3701 north glenridge dr, sherman oaks, DIR-2017-1105-DRB-SPP-MSP-1A1 message

Greetings members of the South Valley Area Planning Commission

The excavation and shoring

EXHIBIT A

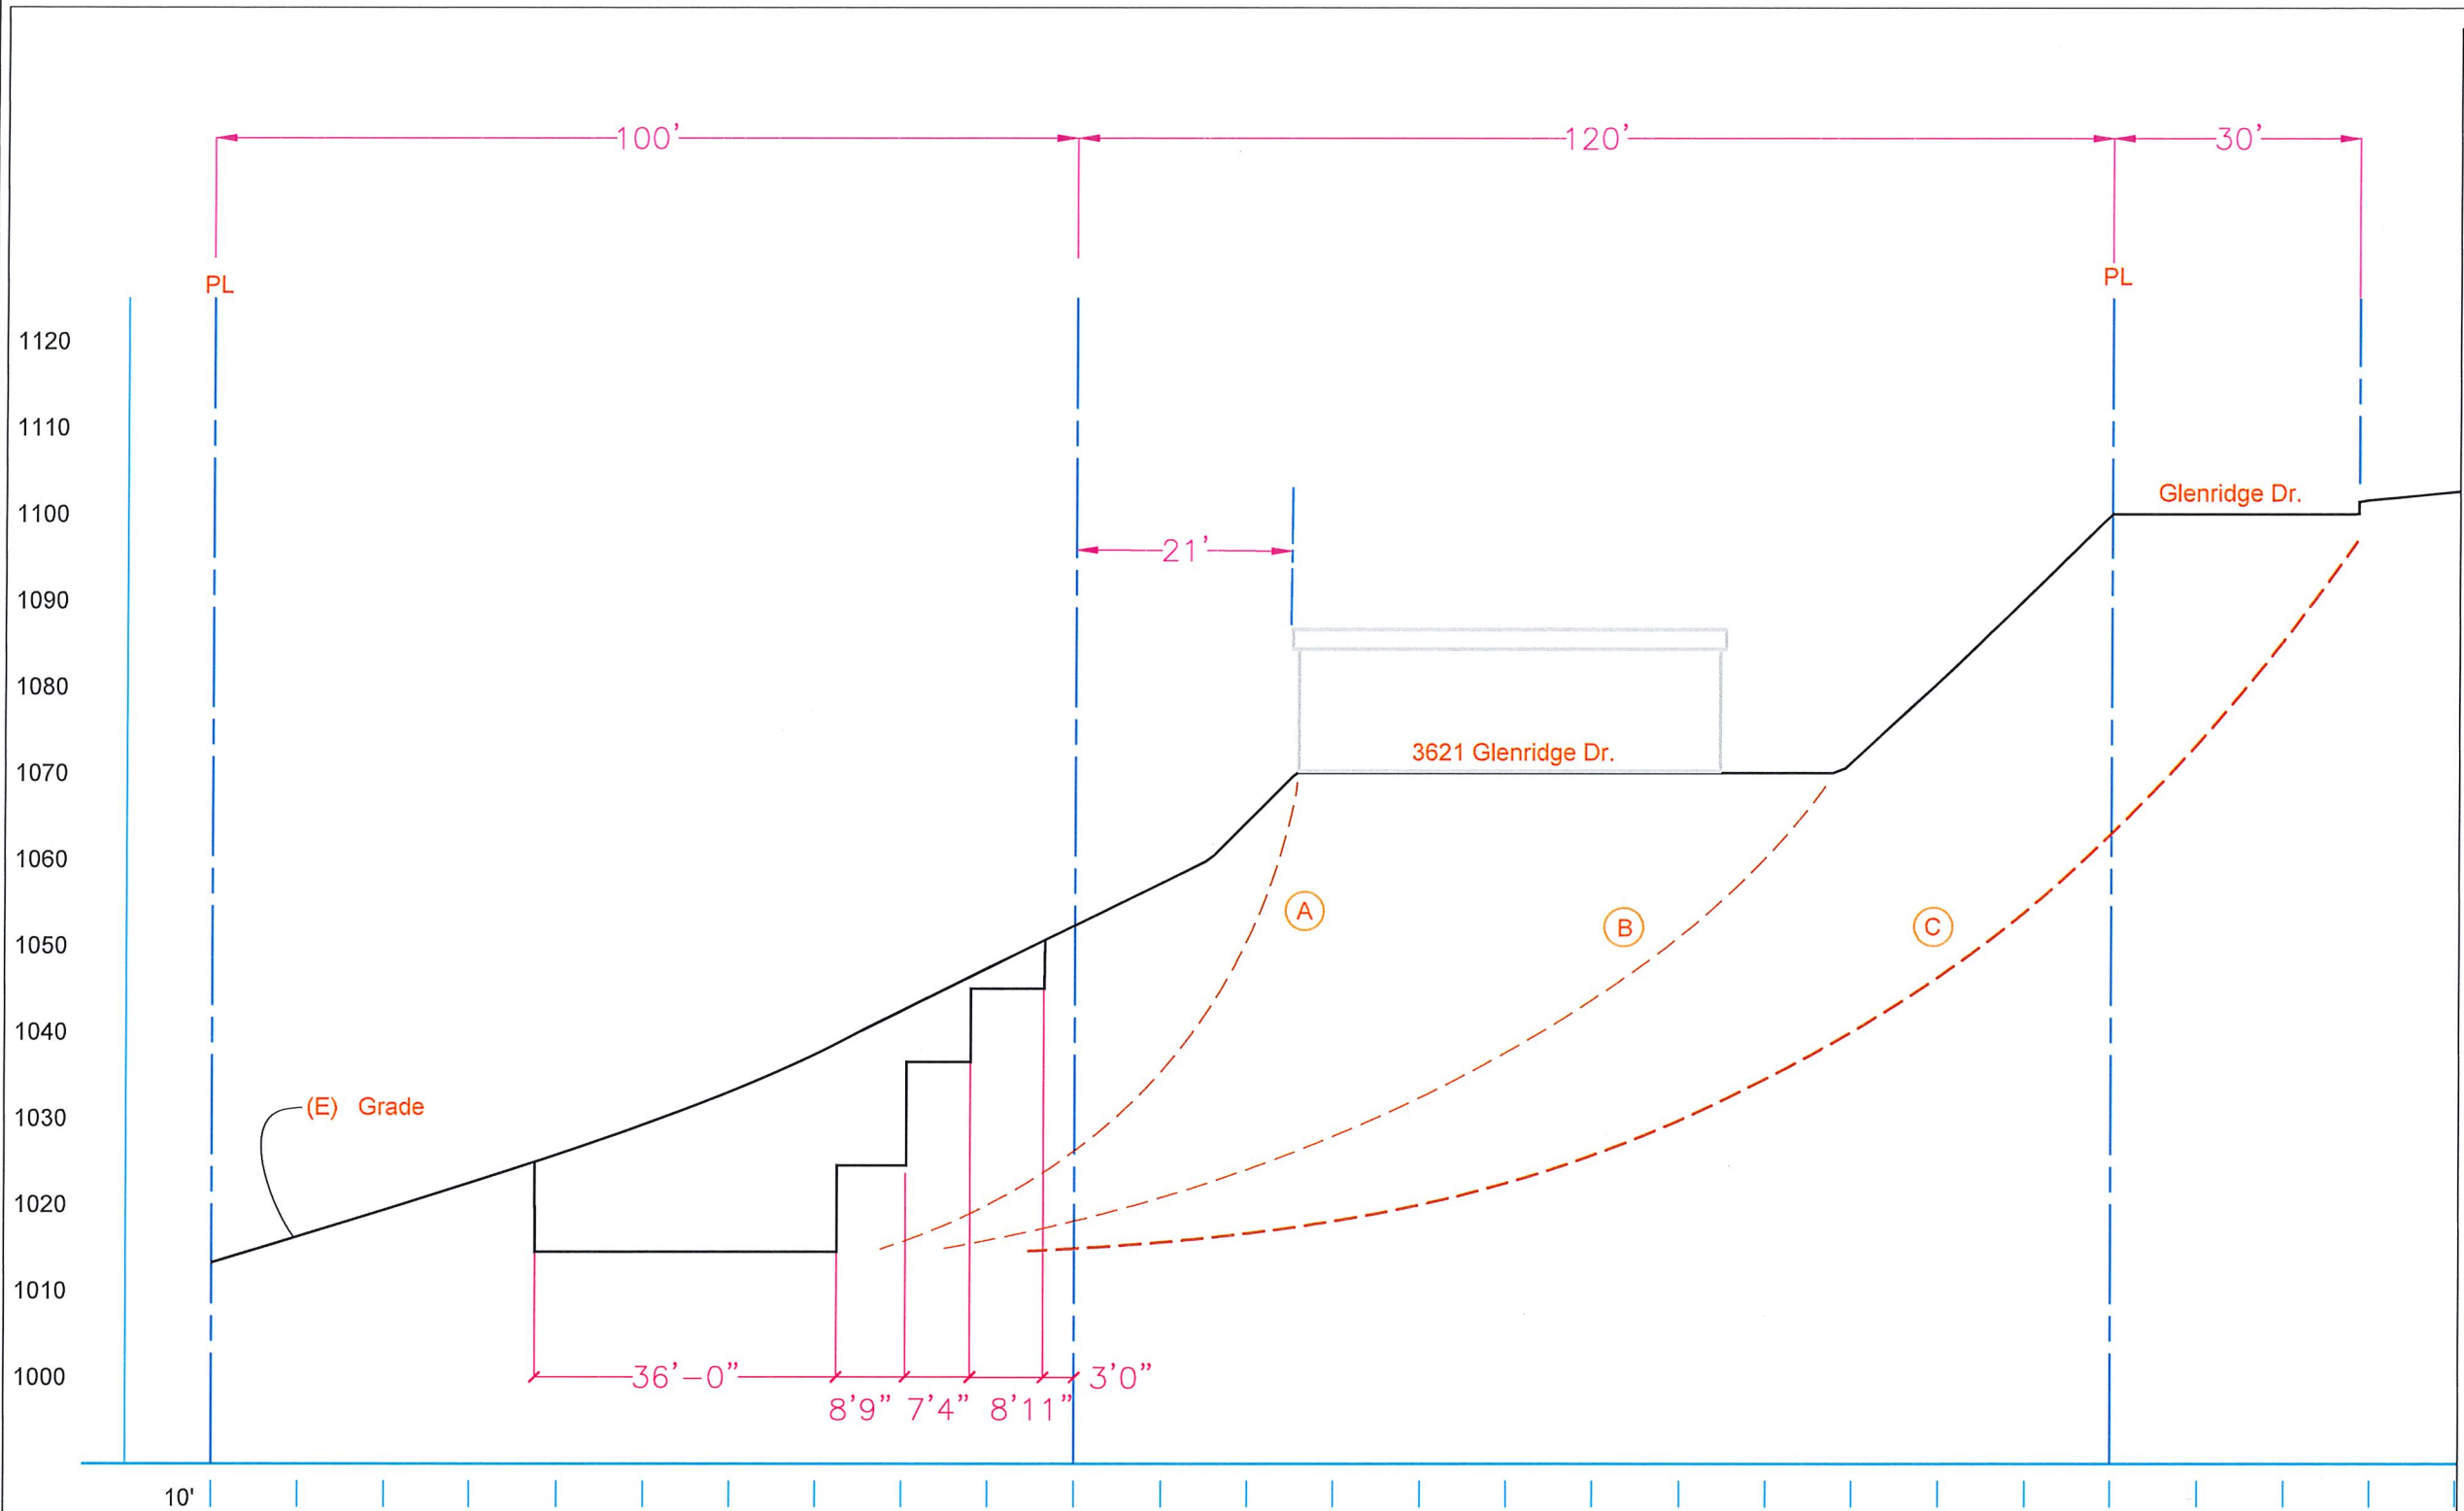
*The depth of the excavation thirty five (35) feet presents a significant challenge to shore up the properties in questions. It is important to note that at this juncture the required shoring of the properties to the east also constitutes a "**de facto**" shoring of the public street -Glenridge drive. Therefore it is recommended that an E permit be applied for and proper notice--not just the 30 day statutory requirement but done immediately with plans and calculations submitted to the property owners for independent verification by a licensed structural engineer (paid for by the applicant). As shown on the attached Exhibit-A the excavation of the basement is approximately **85 Ft.** below street level. Thus if you remove the lateral support of the existing structure at the basement level you remove the lateral support at the street. I have prepared Exhibit-A (attached) to show the depths of excavation and three possible slope planes that could be considered.*

The plans call for seven (7) rows of shoring pile but the slope stability diagrams show only four (4) applicant should clarify

EXHIBIT - B

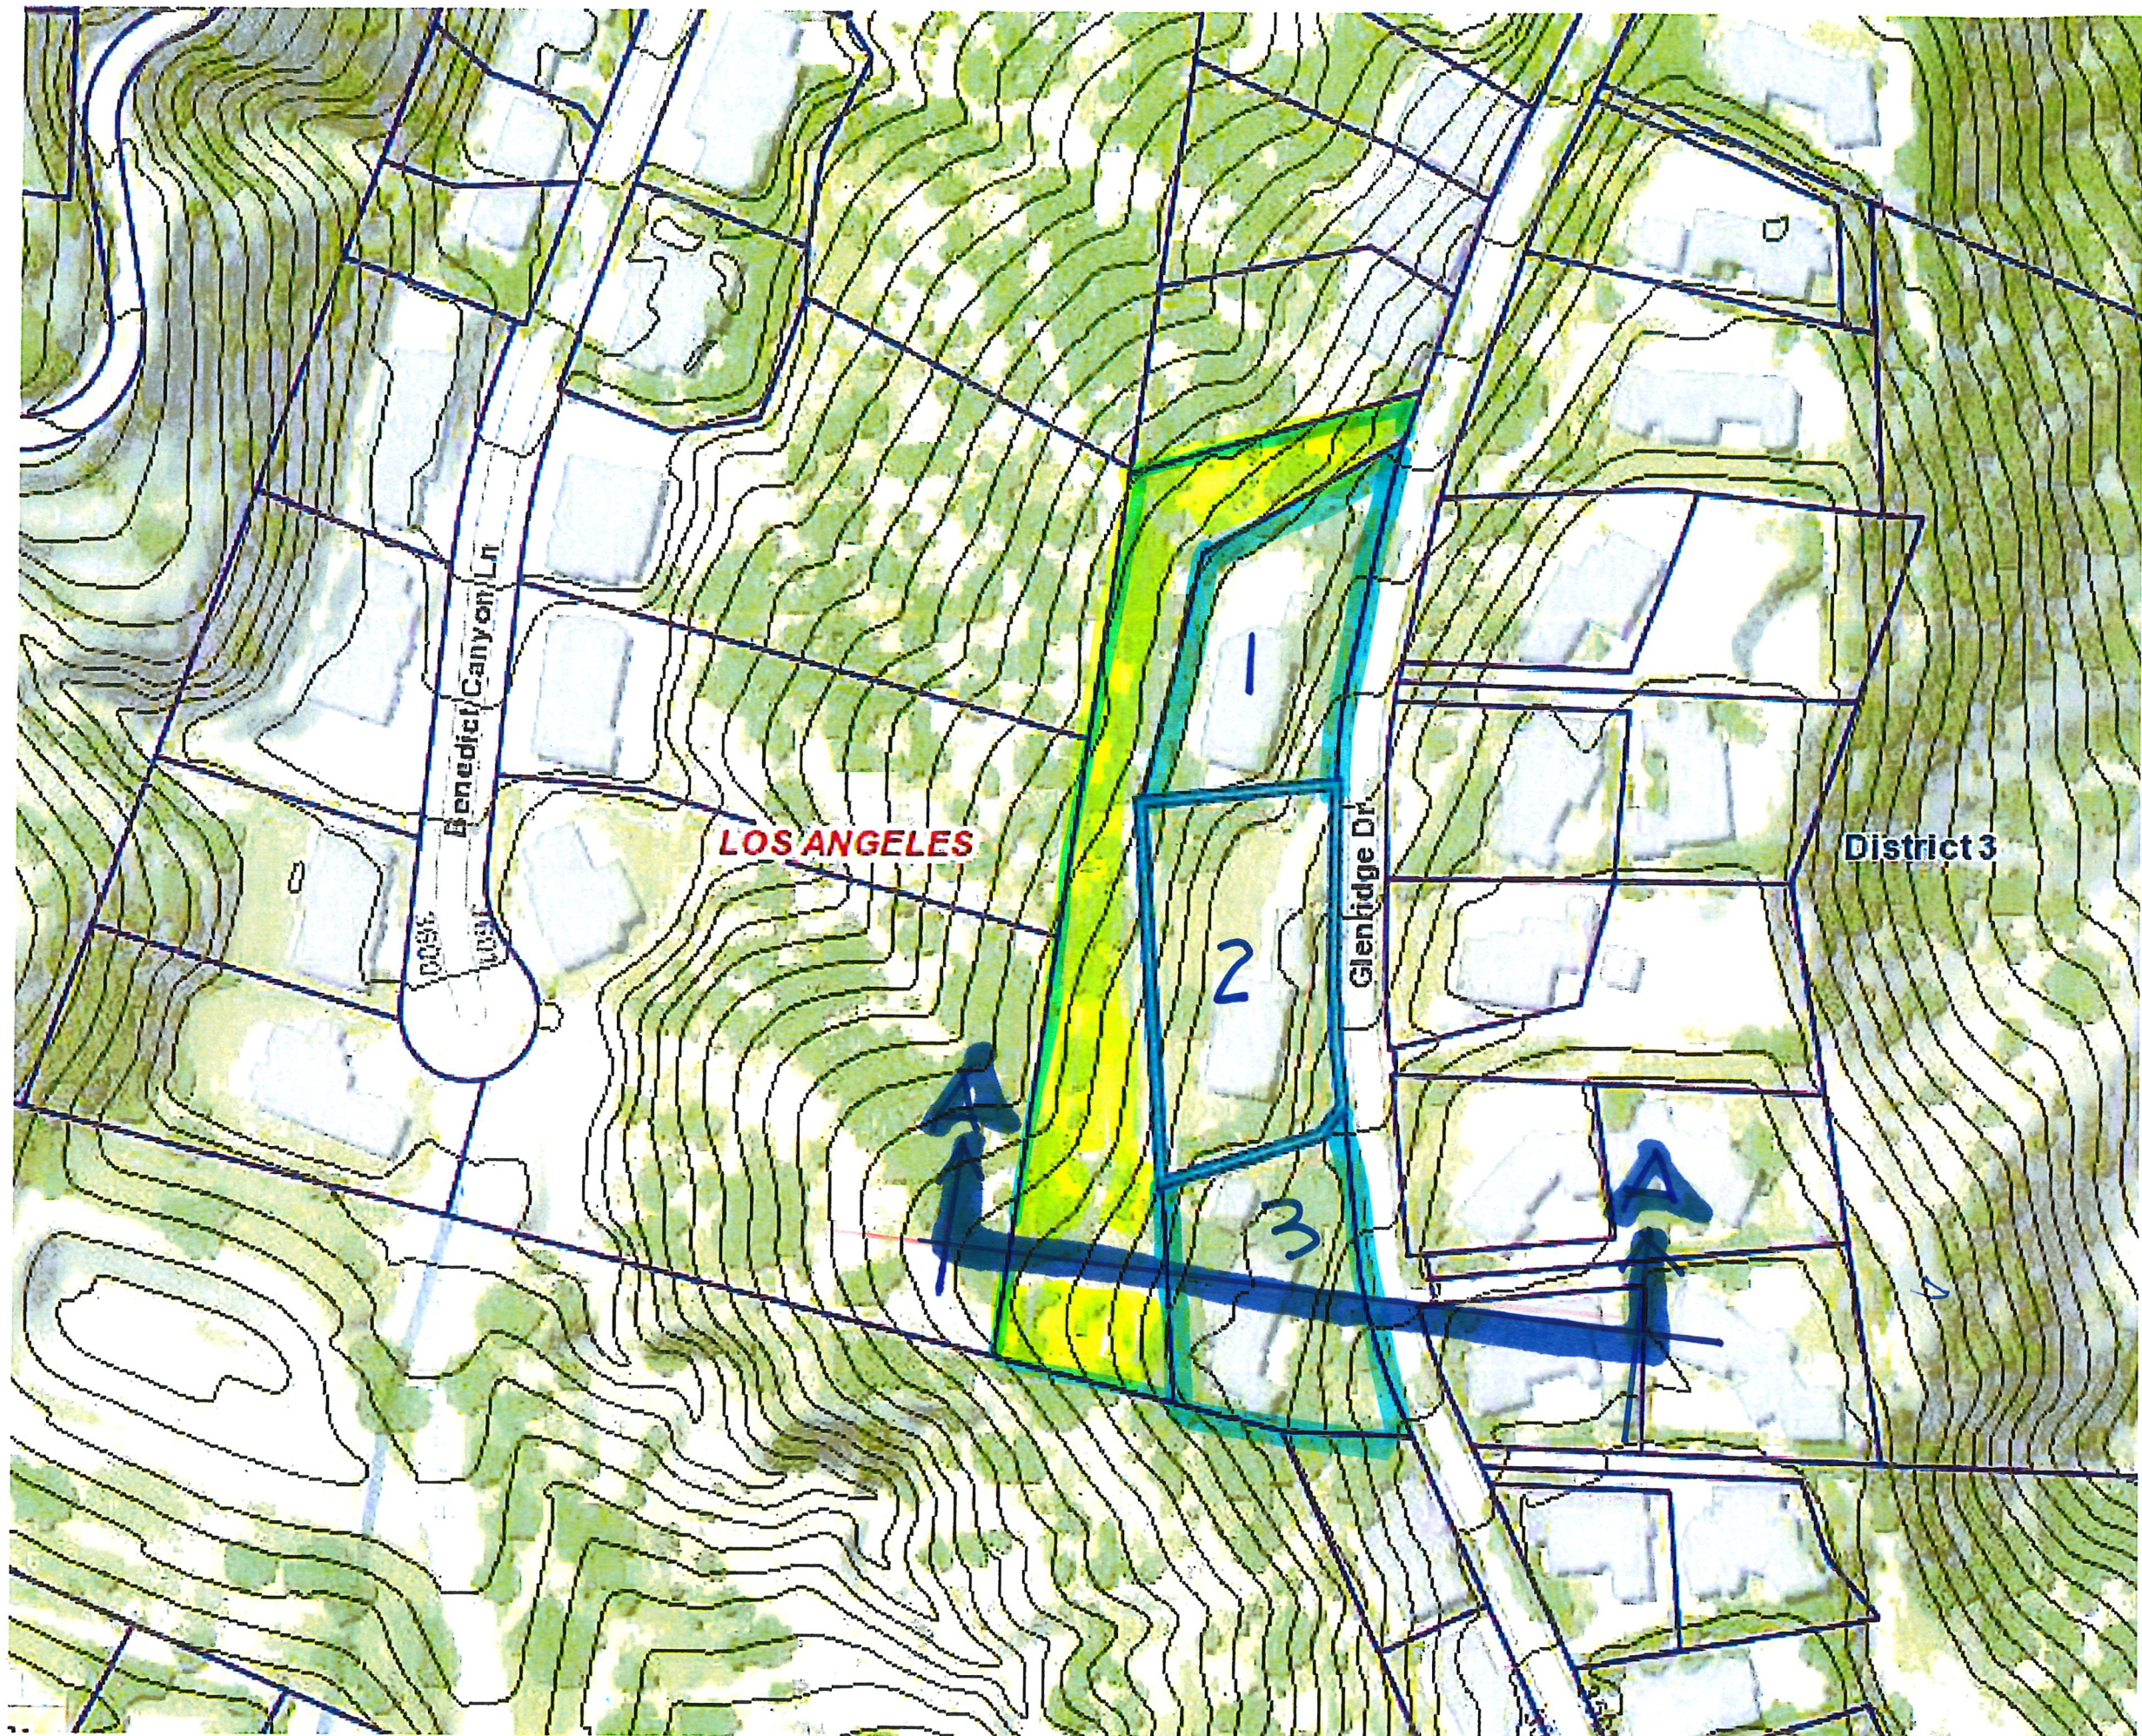
It is good to note that the cross section details that were submitted for review by the applicant conveniently omitted cross section details thru the upslope property and across the adjacent road (Glenridge Dr.)

MISSING
UPSLOPE
DETAIL !
